Feedback on "Cycling and walking – Point Chevalier to Westmere"

Bryan Leyland MSc, FIEE(rtd), FIMechE, FIPENZ.
17 Bangor St, Pt Chevalier, Auckland 1022, NZ. bryanleyland@mac.com

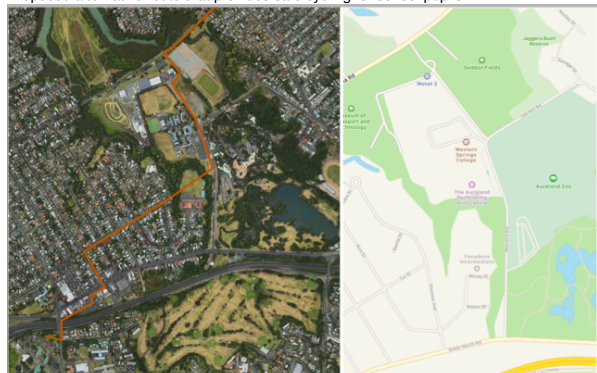
The choice of route creates lots of problems for all road users. If it can be established that there really is a need for a major cycleway, (which I doubt) it would be far better to get the cycleway off the dangerously congested Meola Road as soon as possible and take it along the established road and track through the Jaggers Bush reserve and onto Motions Road. It could then cross to Tui St through the park area or onto Moray Place and thence to Tui St. From there it could go down Kiwi Road to the traffic lights that would take the cyclists across the road safely. Then there would be a short section along Great North Road to Parr Road and along the service lane to join up with the cycleway alongside the north-western motorway. This would be cheaper and safer and provide the cyclists with a much pleasanter environment. As a major bonus it would also provide safe and convenient cycle access for pupils of Western Springs College and Pasadena Intermediate. (See satellite picture and map)

Proposed alternative route that provides safe cycling for school pupils
